RECALL 24V005 REMEDY INSTRUCTIONS – CERTAIN Li3 MODELS ONLY

Make(s): GALLERIA Model(s): MANY, SEE BELOW Model Year(s): 2018 - 2021	Repair Code: RC-093-09-00-004514 Allotted Time: 1.50 HRS. Inspection Code: N/A Allotted Time: N/A
	Concern: In the event the battery boost wire shorts, or fails, it may shut down or damage the power steering of the vehicle. This condition may lead to a crash.	Photo(s) Required: YES, POST REMEDY Prior Authorization Required: YES Part(s) Kit Number: F100503421 Part(s) Return: N/A

CERTAIN 2020 – 2021 GALLERIA: GAB24AM, GAB24FLM, GAB24QM & GAB24TM

FIG. 1

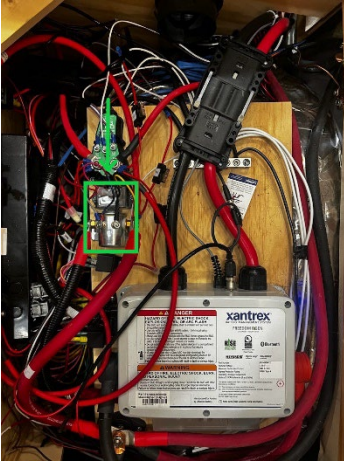
STEP 1: LOCATE AND ACCESS THE COMBINER SOLENOID AND RELAY IN THE MAIN ELECTRICAL COMPARTMENT) (FIG 1.);

FIG. 3

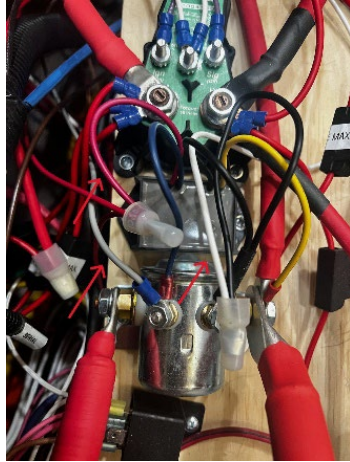
STEP 3: CUT/DISCONNECT COMBINER RELAY *RED* 16 AWG WIRE FROM HARNESS - (RECONNECT *RED* 16 AWG AND *RED* 16 AWG IN HARNESS) (FIG. 3);

FIG. 4

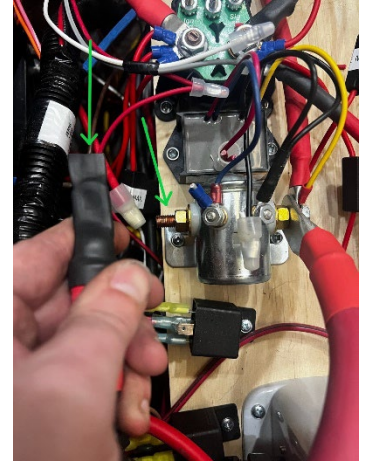
STEP 4: USING A 1/2" SOCKET REMOVE THE *RED* 2 AWG CHASSIS BATTERY CABLE CONNECTED TO THE COMBINER SOLENOID (FIG. 4);

FIG. 5

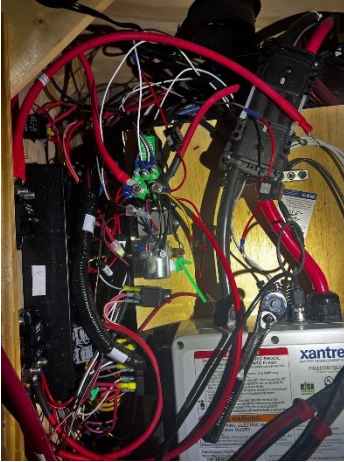
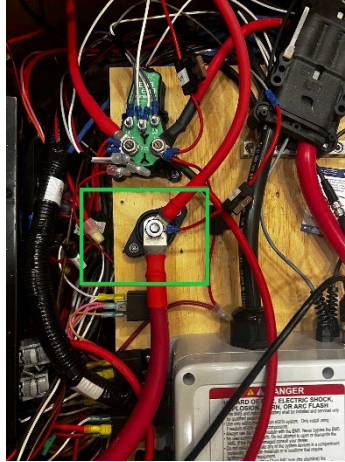
STEP 5: USING A 1/2" SOCKET REMOVE THE *RED* 4/0 AWG HOUSE BATTERY CABLE, *RED* 2 AWG CABLE, AND IN-LINE FUSE HOLDER FROM

SOLENOID (FIG. 5);

FIG. 1

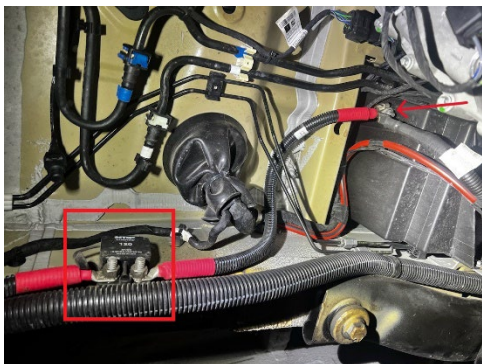
STEP 1: LOCATE AND ACCESS 120 AMP BREAKER (FRONT DRIVER SIDE - UNDERCARRIAGE OF UNIT) (FIG. 1);

FIG. 3

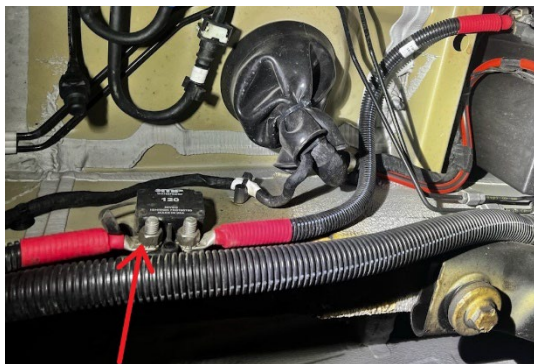
STEP 3: REMOVE THE RED 2 AWG CABLE CONNECTED TO THE AUXILIARY SIDE OF THE BREAKER USING A 9/16" SOCKET (FIG. 3);

FIG. 3B

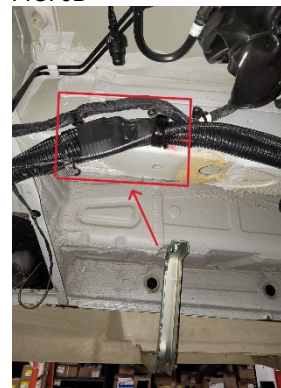
3B. TAPE CABLE INTO HARNESS (FIG. 3B);

FIG. 4A

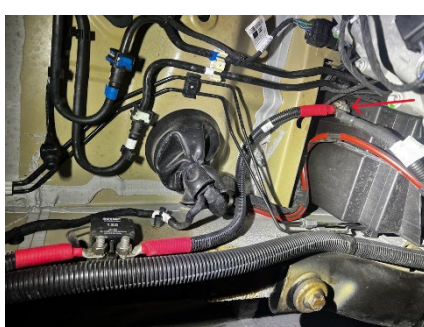
4A. REMOVE ZIP TIES OR CLAMPS RESTRICTING THE CABLE TO THE OEM TERMINAL POSTS (FIG. 4A);

FIG. 4B

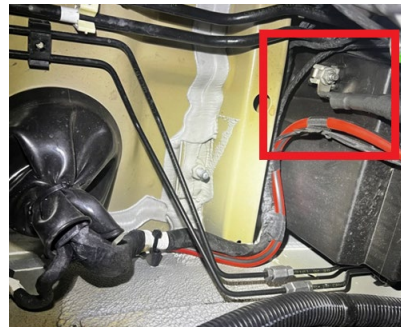
4B. REMOVE THE RED 2 AWG CABLE FROM THE POST LEAVING OEM WIRING UNDISTURBED THEN TORQUE TO 141.62 IN-LBS. (FIG. 4B);

FIGURE 2

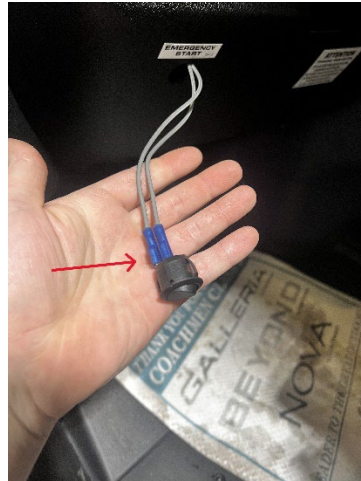
STEP 2: USING THE PRY TOOL, PULL THE SWITCH OUT FROM THE DASH AND DISCONNECT THE SWITCH FROM THE GREY 16 AWG WIRES (FIGURE 2);

FIGURE 3

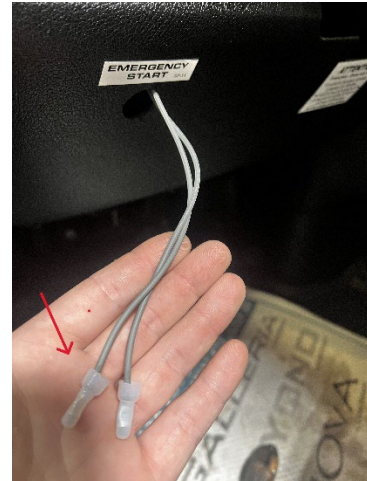
STEP 3: CAP OFF BOTH GREY 16 AWG WIRES AND TAPE TOGETHER (FIGURE 3);
